WHITE CITY REDEVELOPMENT

Hakoah Club Limited
Response to Submissions to Woollahra Council

18 June 2020

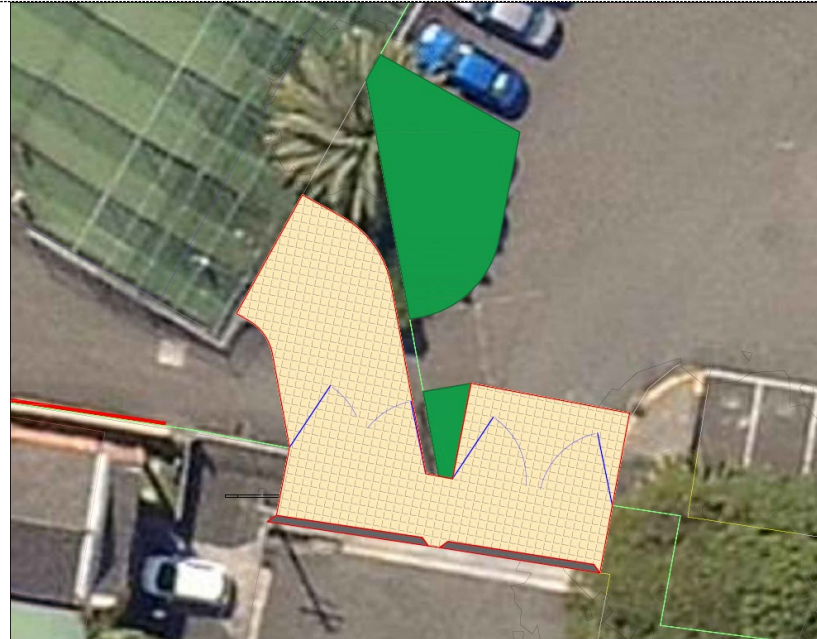
c) SGS Safe drop off zone	6	<p>Comprehensive proposal for safe managed drop-off and collection arrangements submitted to school.</p> <p>A proposal has been received from the school's consultants, for an alternative approach to drop-off and pick up traffic management as part of a development the school is undertaking. This solution offers a separate entry and parking area for school parents. We support this proposal</p>

A pedestrian safety proposal, including a pedestrian crossing at Alma Street north was submitted to the school. The driveways arrangement above will include provision for safe pedestrian crossing. Details are being developed by the traffic consultants retained by the school and we expect will be supported by both the proponent and the school.
